CNL-18-039

Sequoyah Nuclear Plant, Units 1 and 2
Renewed Facility Operating License Nos. DPR-77 and DPR-79
NRC Docket Nos. 50-327 and 50-328

Subject: Tennessee Valley Authority Response to NRC Request for Additional Information related to Sequoyah Nuclear Plant, Units 1 and 2, License Amendment Request to Revise Emergency Plan Staff Augmentation Times (SQN-TS-17-05)

TVA Response to NRC Request for Additional Information

Typical Transition of Command and Control Functions

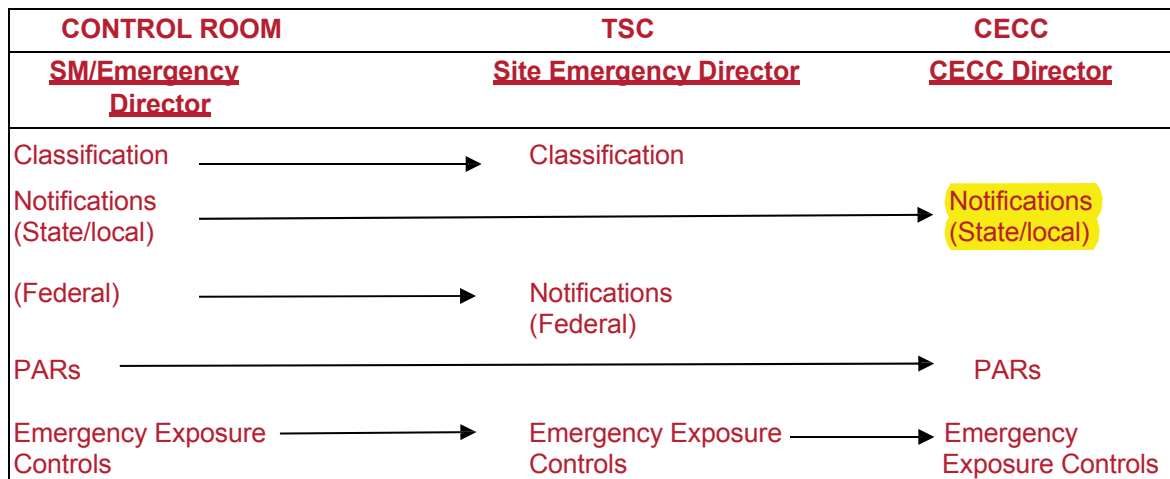
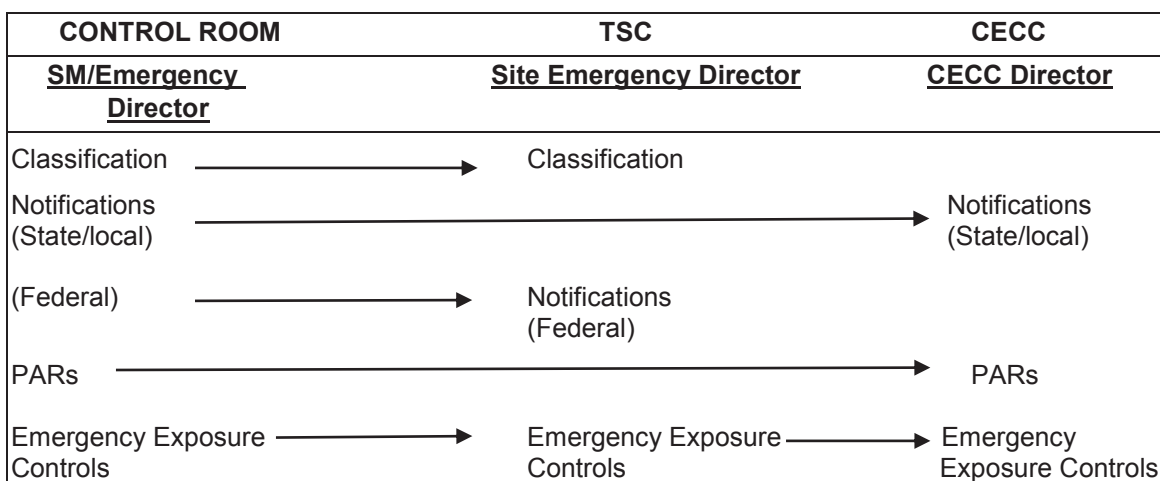
The NRC staff could not determine how the Site Emergency Director (SED) duties were transferred from the Shift Manager (SM) during radiological events. The SQN Site 60 Minute Comparison table, provided in Attachment 3 to Enclosure 1 of TVA's September 29, 2017 letter, shows four senior managers for the current emergency plan, while the SQN Site 30 Minute Comparison table, also provided in Attachment 3 to Enclosure 1 of TVA's September 29, 2017 letter, shows three senior managers responding within 60 minutes for the proposed plan. The Site Emergency Organization table provided in Section B.5 of Appendix B of the TVA Radiological Emergency Plan provides that the SM will transfer protective action recommendation (PAR) responsibility to the Central Emergency Control Center (CECC) Director and the remainder of the command and control responsibilities to the Site Emergency Director (SED) at the Technical Support Center (TSC). The SED will retain classification and notification (Federal) responsibilities, and transfer emergency exposure controls and notification (State/local) responsibilities to the CECC Director.

The proposed SQN Plan commits to 60-minute activation times for the TSC and CECC. Once the Minimum Activation Staff Positions (MASP) have been filled for the TSC or CECC, the lead position declares that facility 'activated.' After activation of the TSC or CECC, the facility leader obtains a turnover briefing. The briefing concludes with the transfer of Command and Control functions from the SM to the appropriate facility leader as described below.

Note: The TSC retains the capability to perform all Command and Control functions should the CECC be unavailable for any reason. The Transfer of Command and Control diagram in Section B.5 has been revised to better reflect facility capabilities.

This process, as well as the 60-minute activation criteria for the TSC and CECC, ensures that the SM is relieved in a timely manner. As a result, the proposed SQN Plan does not extend the timeframe during which the SM maintains responsibility for command and control functions.

**Figure B-1
SITE EMERGENCY ORGANIZATION
(Including Minimum Staffing and Augmentation) (See Note 1)**

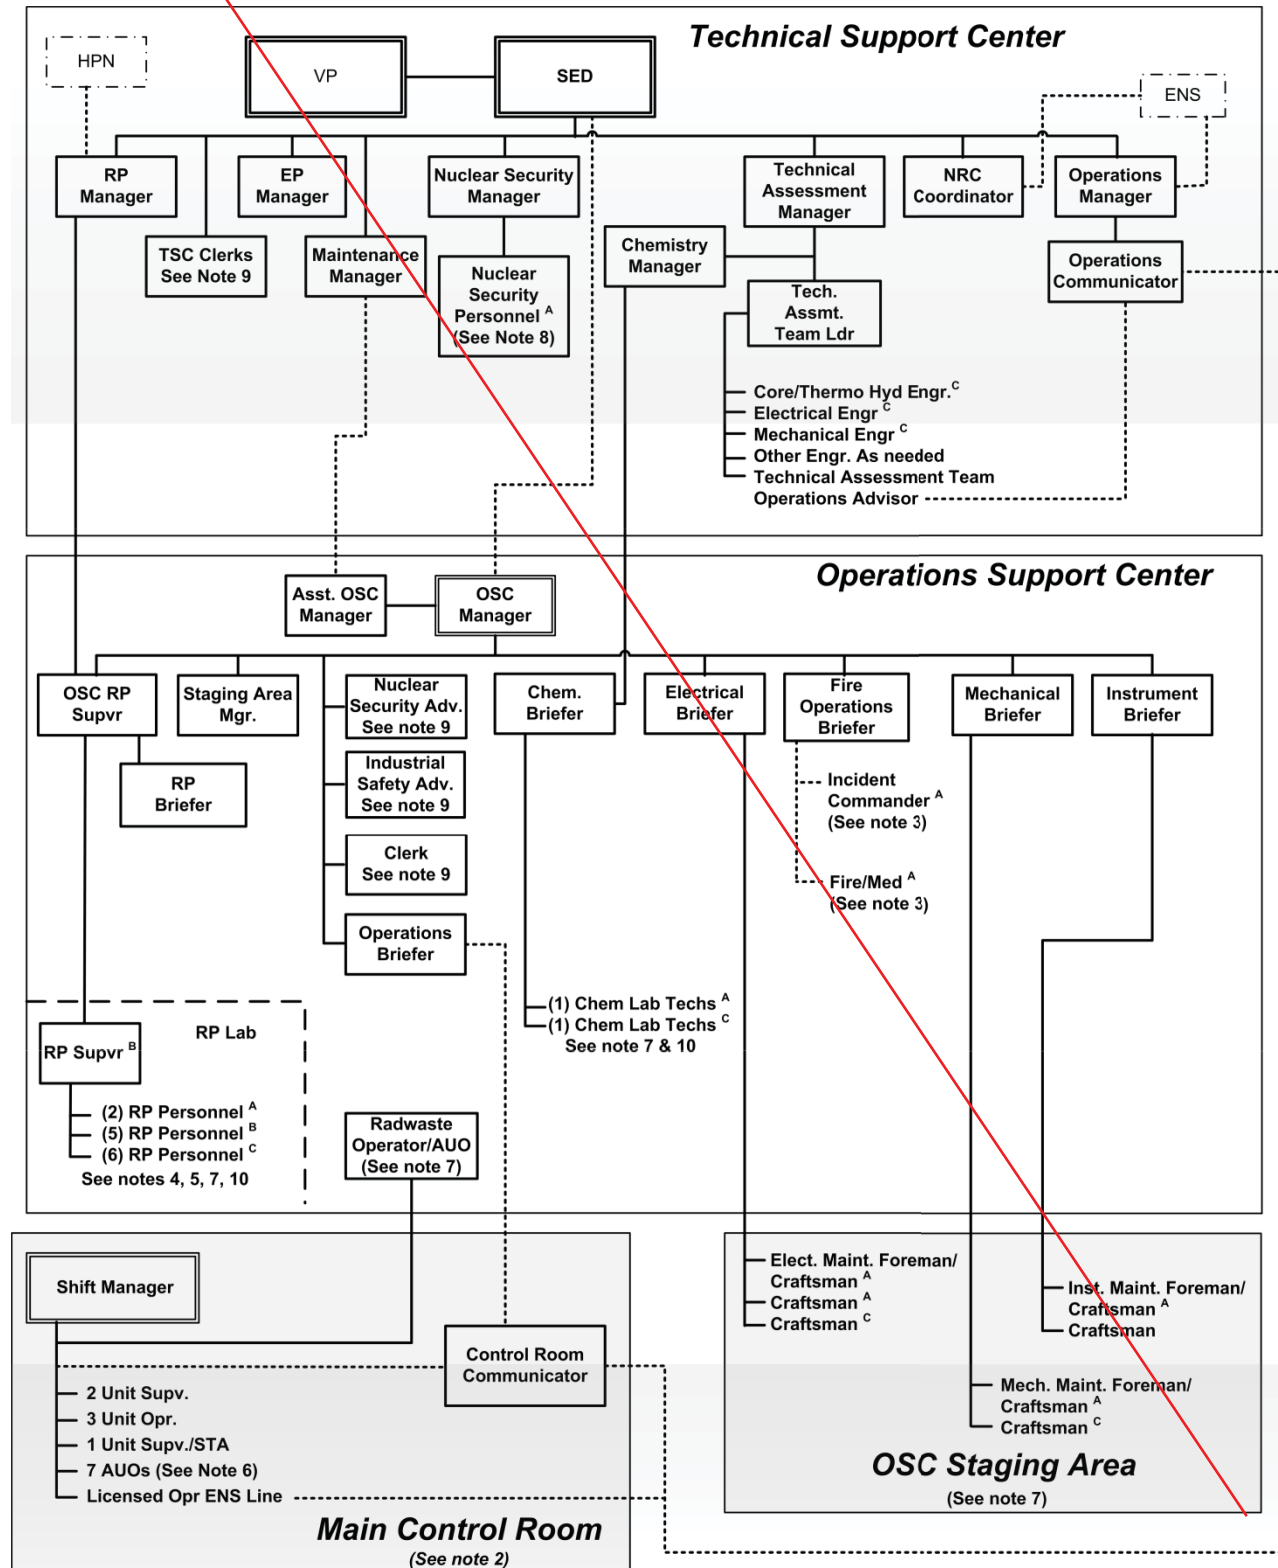
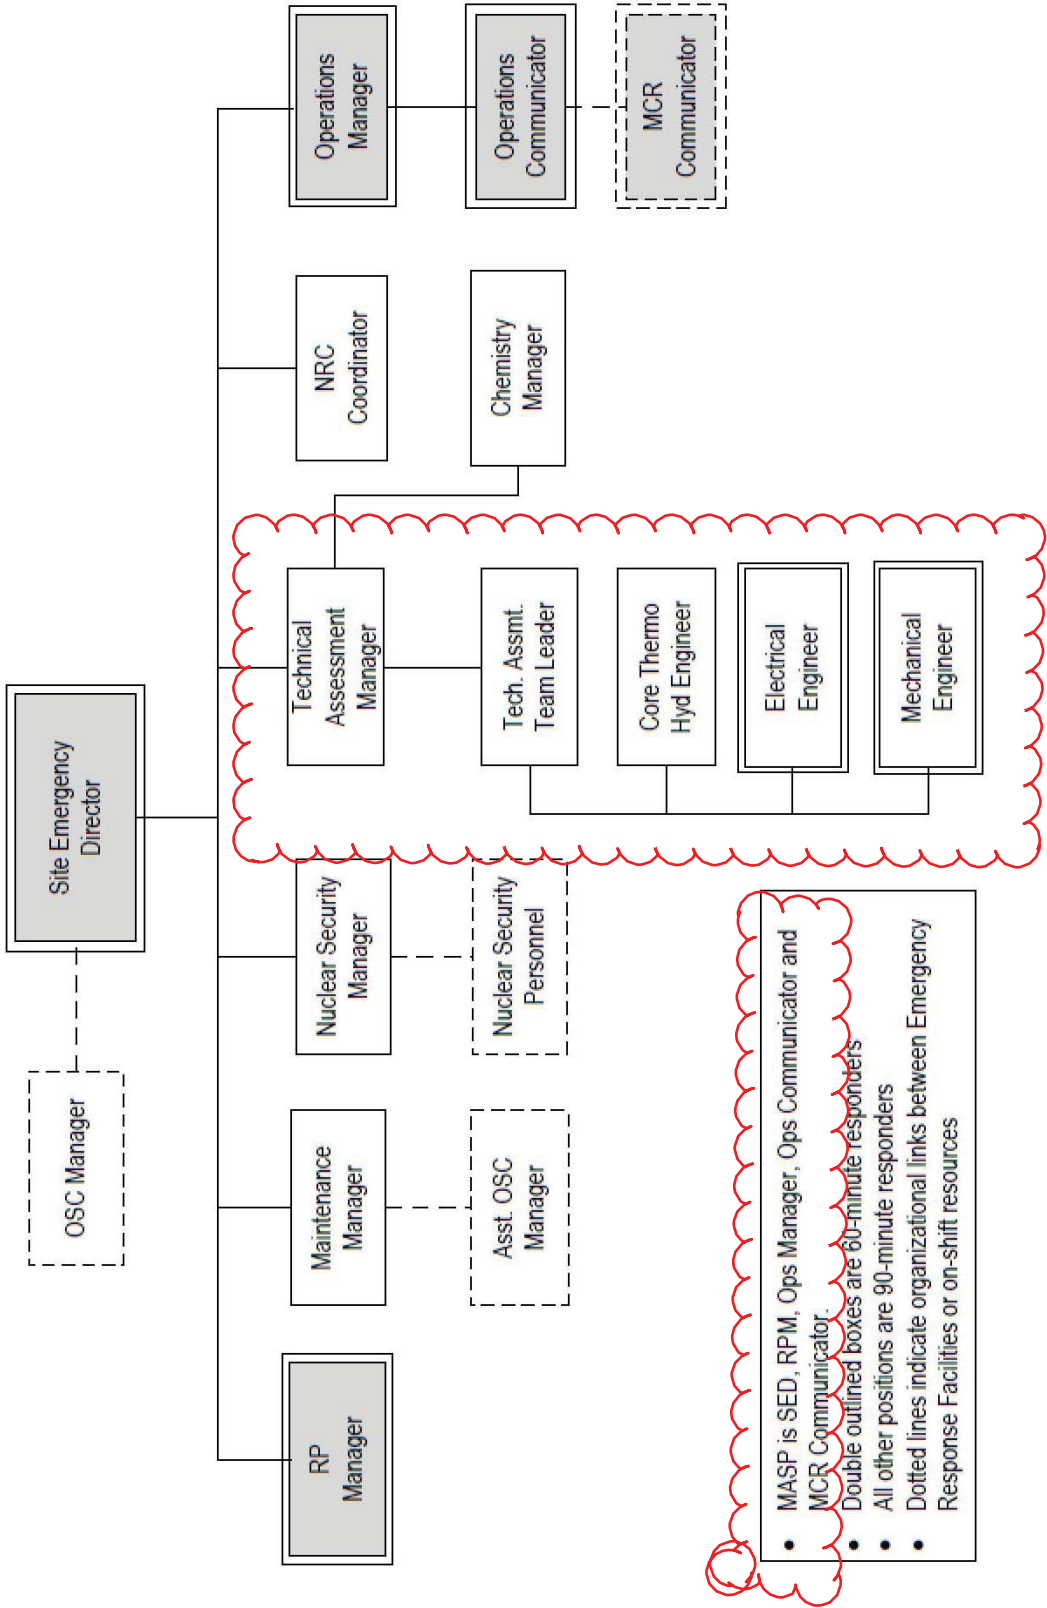
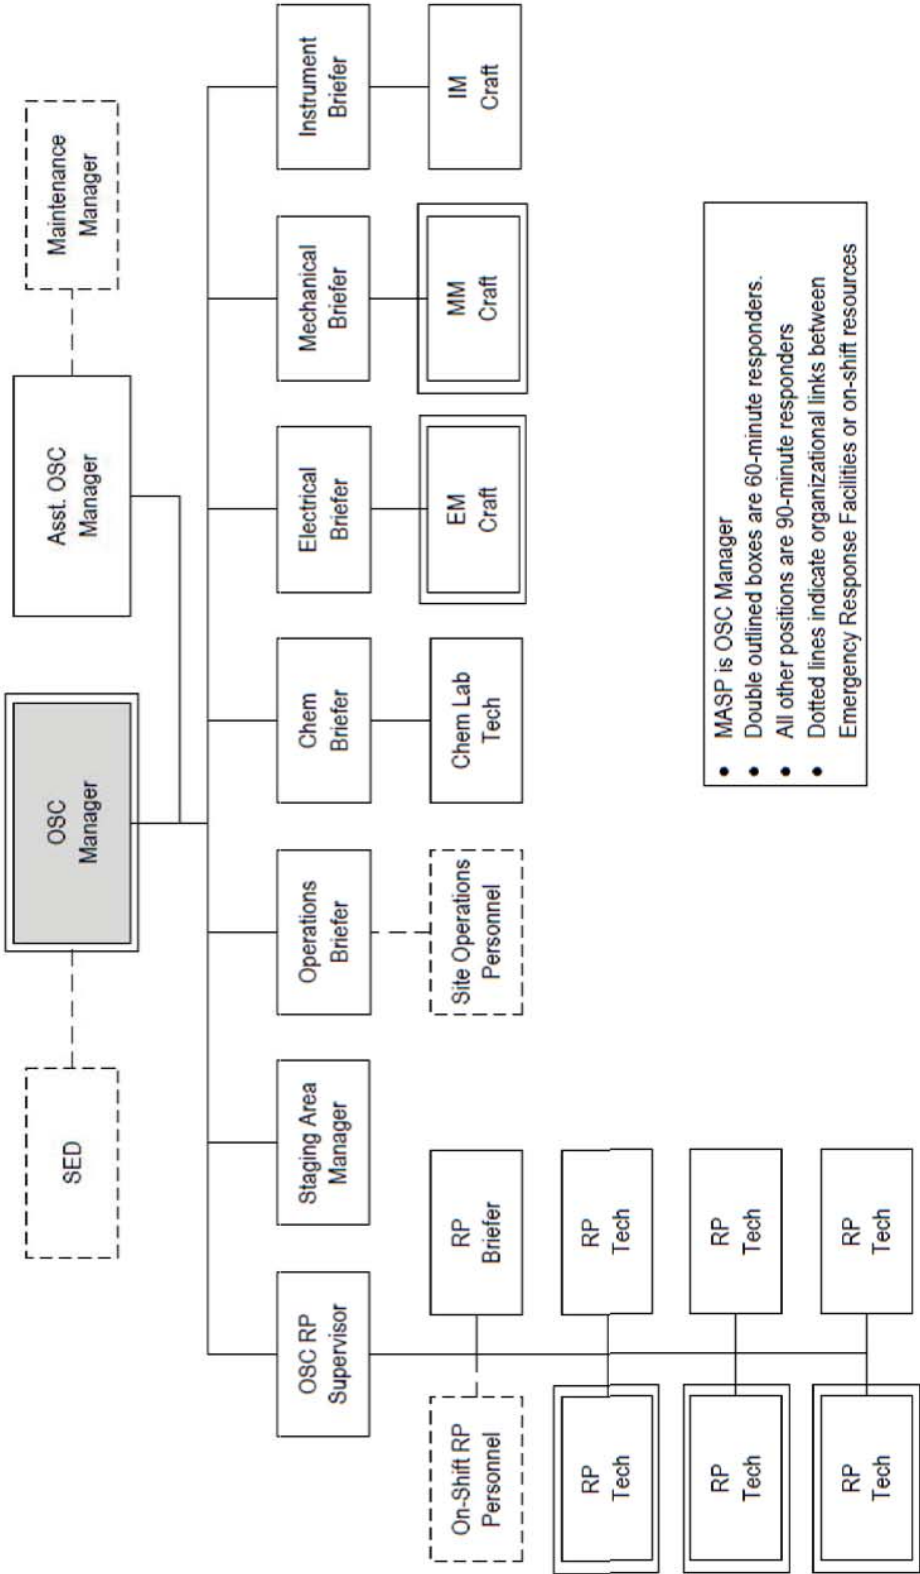
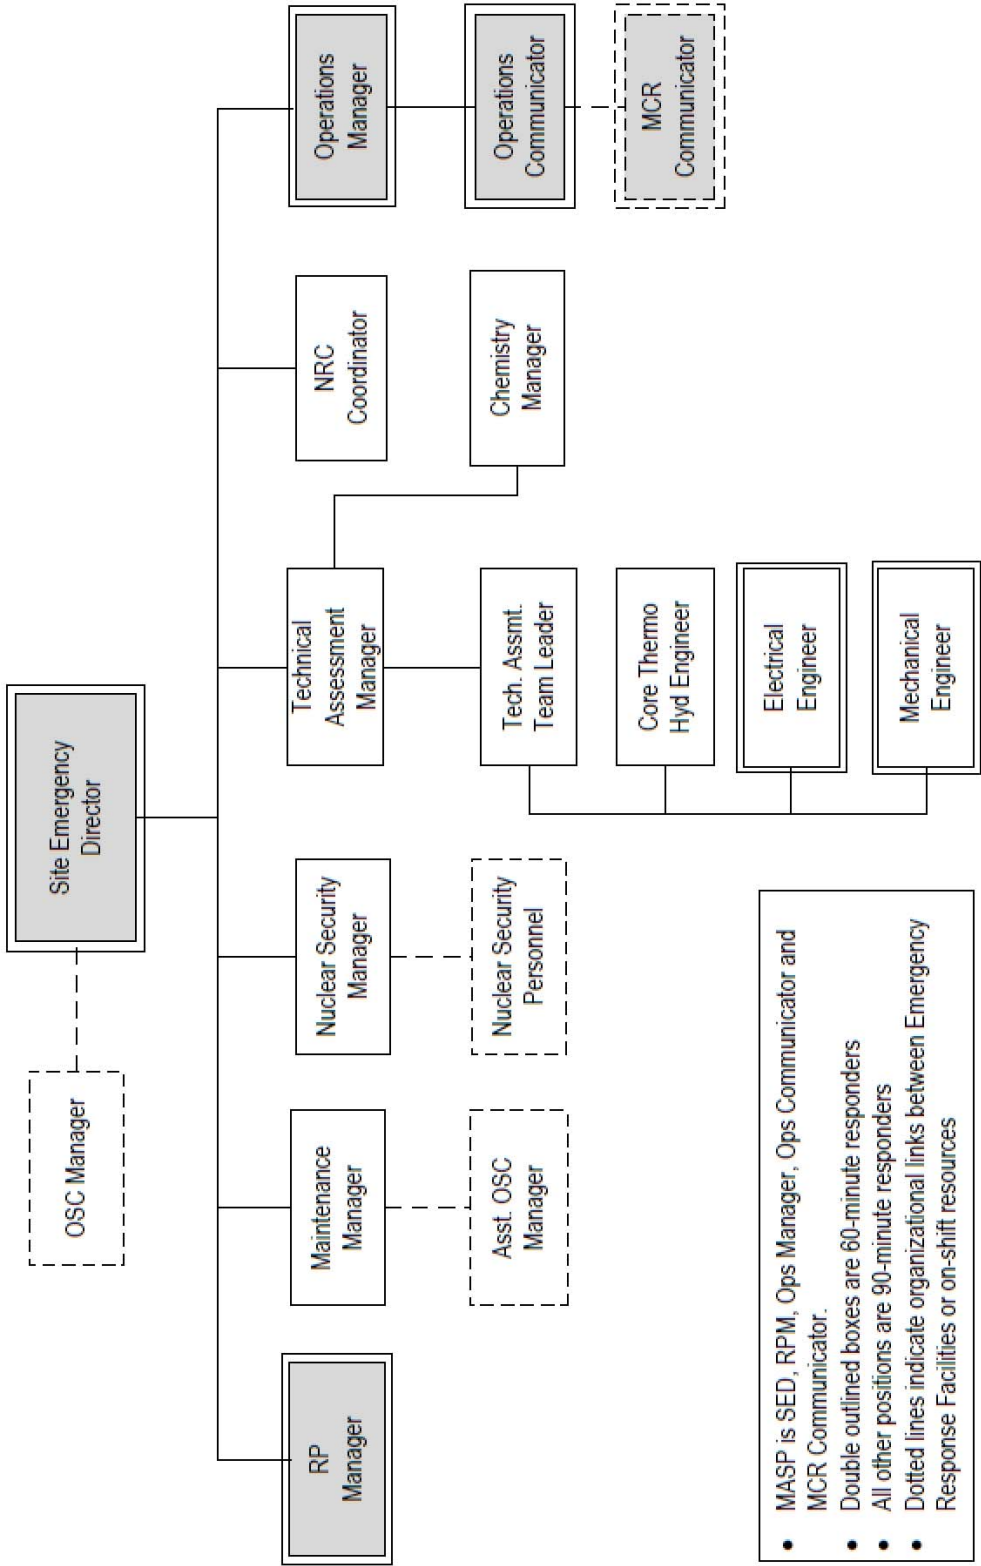
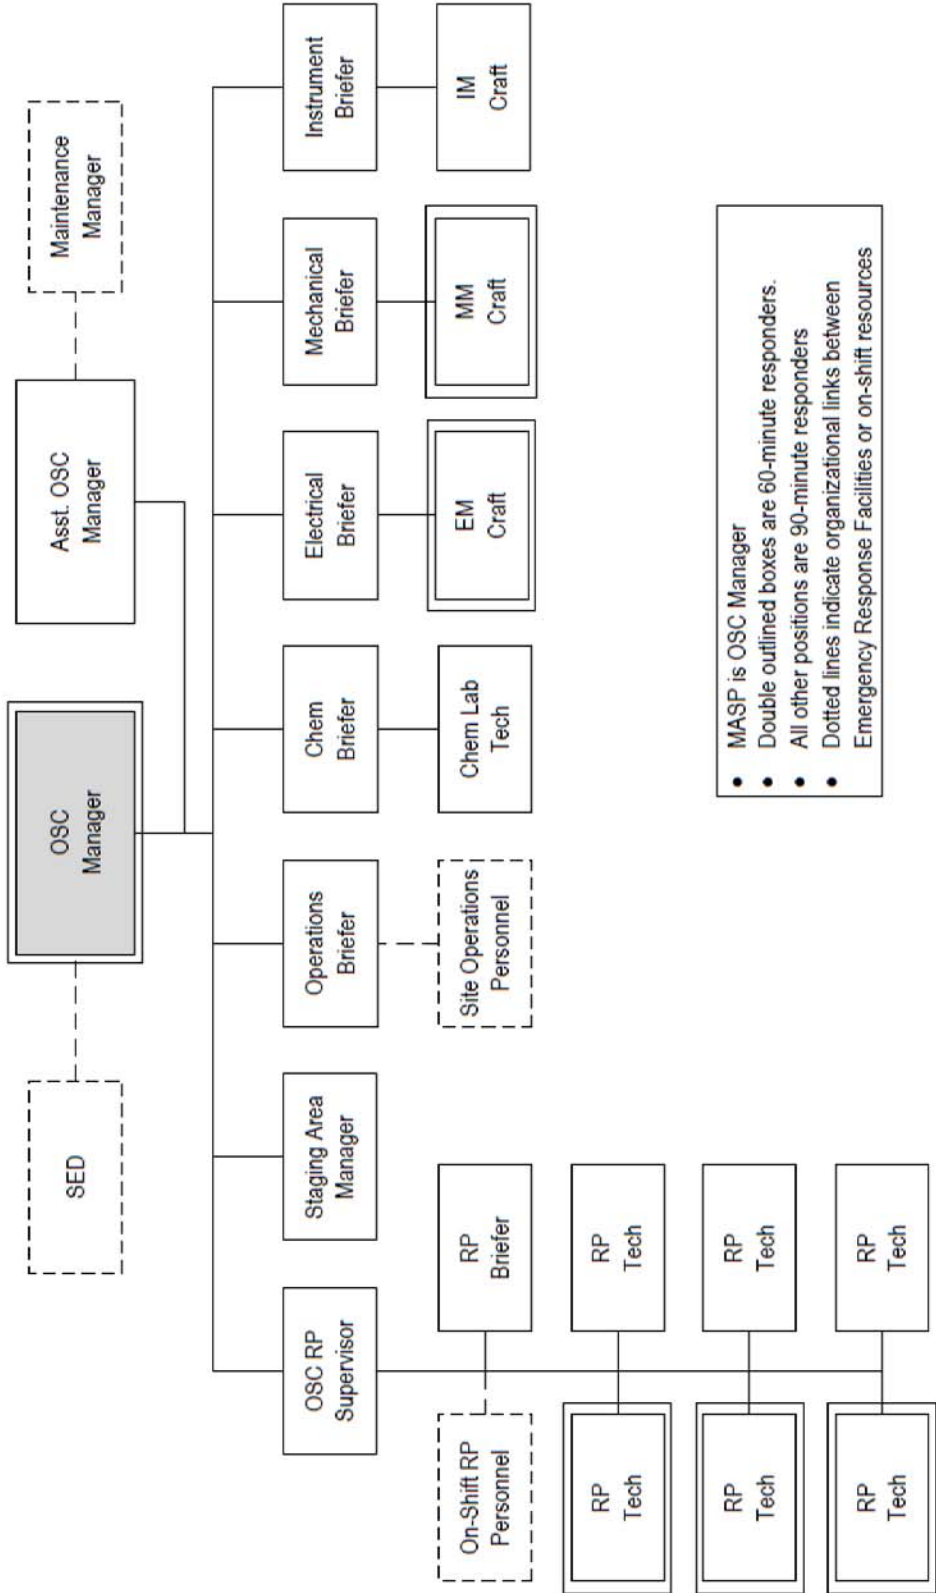
TVA proposes to extend the response times for the Reactor Engineer, Electrical Engineer and Mechanical Engineer positions from 60 minutes to 90 minutes. TVA provides that the TAM and TATL positions will maintain the capability to transfer the Core/Thermal Hydraulics function from the Control Room to the TSC at 60 minutes. However, the NRC staff could not determine how transferring the Core/Thermal Hydraulics function at 60 minutes supported extending the augmentation time of the Reactor Engineer, Electrical Engineer, and the Mechanical Engineer to 90 minutes.

- a) Provide justification for extending the response time of the Electrical Engineer, who provides coverage related to electrical or I&C equipment, for an additional 30 minutes. This justification should provide either the unique characteristics of SQN that allow the 30 minute extension, or explain how this function will be performed at 60 minutes*
- b) Provide justification for extending the response time of the Mechanical Engineer, who provides coverage related to mechanical equipment, for an additional 30 minutes. This justification should provide either the unique characteristics of SQN that allow the 30 minute extension, or explain how this function will be performed at 60 minutes.*

The proposed SQN Plan has been revised to provide for specific augmentation of the mechanical and electrical engineering functions at 60 minutes. As a result of the change in response strategy for electrical and mechanical engineering functions, as well as the core thermal hydraulics function described in the RAI-4 response, the TAM/TATL augmentation times are being revised to 90 minutes supporting the full engineering function augmentation times. This change aligns augmentation of the electrical engineer and mechanical engineer with staff guidance. The TAM/TATL positions are no longer required at 60 minutes to fulfill the electrical and mechanical engineering functions.

Figures B-1 and B-2 of the proposed SQN Plan are revised to reflect the changes described.
